SECTION SUMMARY AND INDEX

$\frac{23}{\text{SECTION}}$ $\frac{16}{\text{TOWN}}$ $\frac{7}{\text{RANGE}}$

April 9, 1984

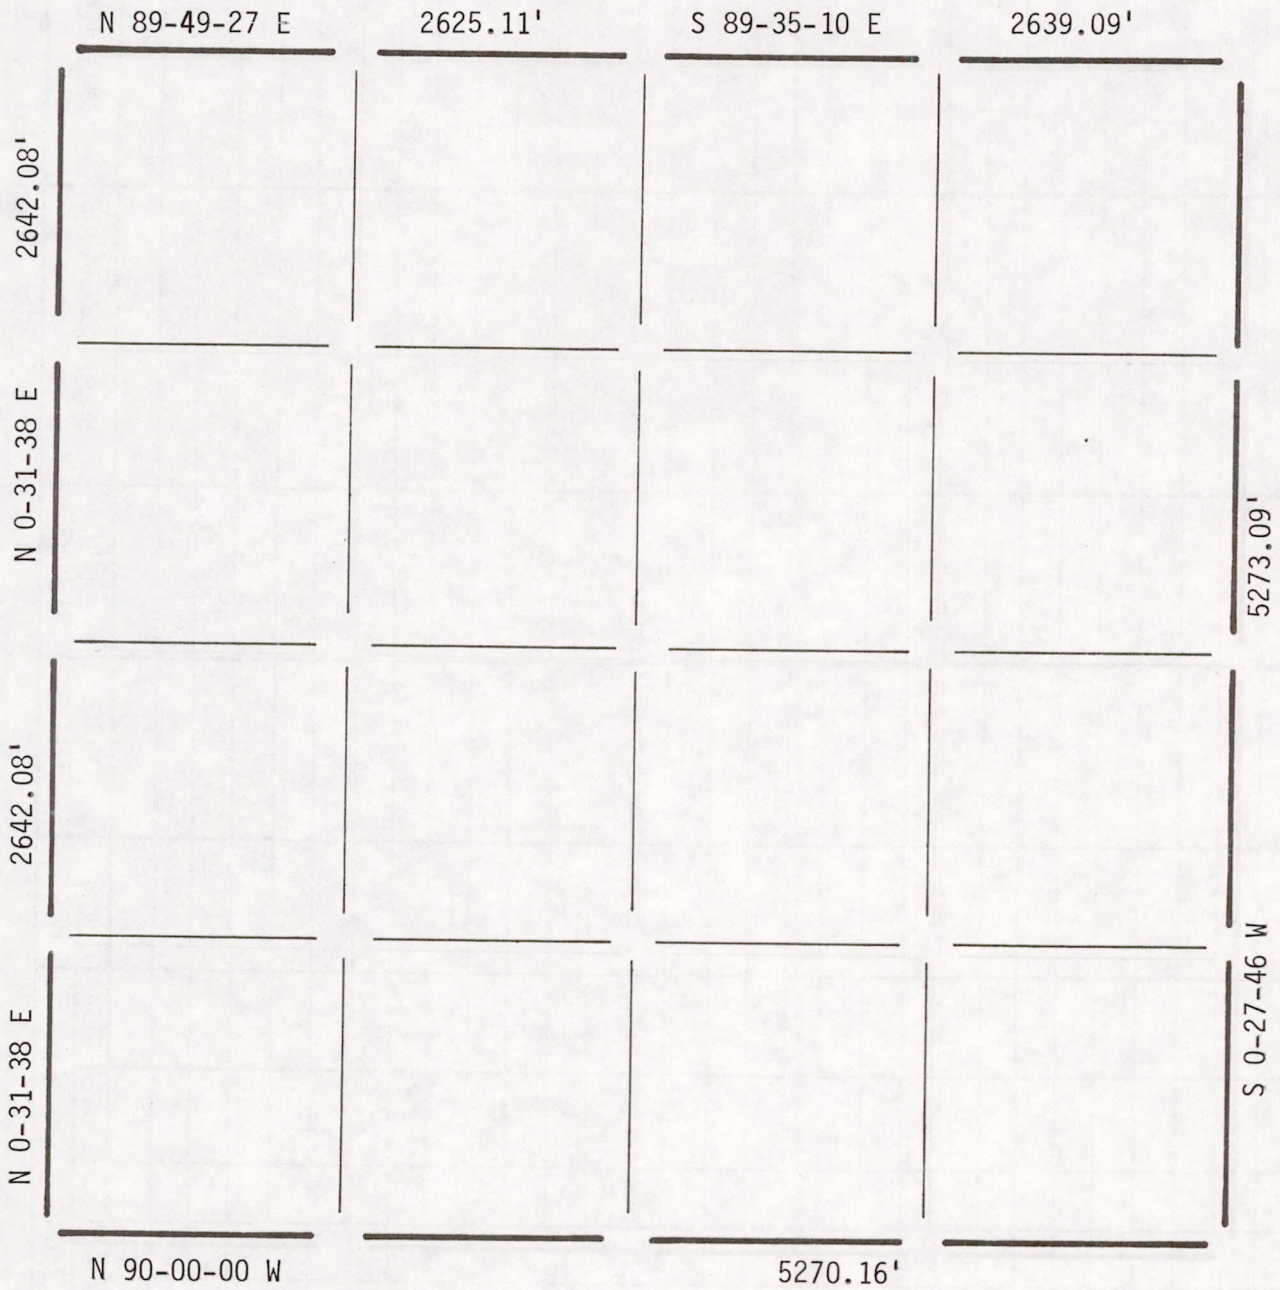
Back in 1977, I discussed with you the difference that we had in running out Section 23, T16N, R7E, Town of New Chester, Adams County. If you recall at the time, we had excavated with the backhoe and found a stone at the N $\frac{1}{4}$ corner and an old 2" pipe at the NE corner.

We are now surveying the NE $\frac{1}{4}$ of the NE $\frac{1}{4}$ of the Section and as you will see from the map enclosed, your survey encroaches 10 to 18' onto the NE $\frac{1}{4}$ of the NE $\frac{1}{4}$. You will also note on the enclosed Section Summary that we are on the same bearing base as you are, that is the South line of the Section is assigned a bearing of WEST. Although we get the same distance as you show on your survey map between your two monuments, (1281.57'), the bearing is considerably different than what you indicate.

Please let me know what action you intend to take in this matter.

Thank you for notifying me about the difference between our surveys in Section 23, T16N, R7E.

I believe that our Section Line fell on the centerline of Elk Avenue. It appears that the NE corner and the Section Line that you have drawn also falls on the center of Elk Avenue.

When we did this survey, we did traverse to Section corners on the South line of the Section and completely around the Section.

I can't believe there is such a difference North and South. I must go out to this area and remeasure the distances to the survey irons again and recheck our old calculations.

I will let you know what we find out from the traversing and calculations.
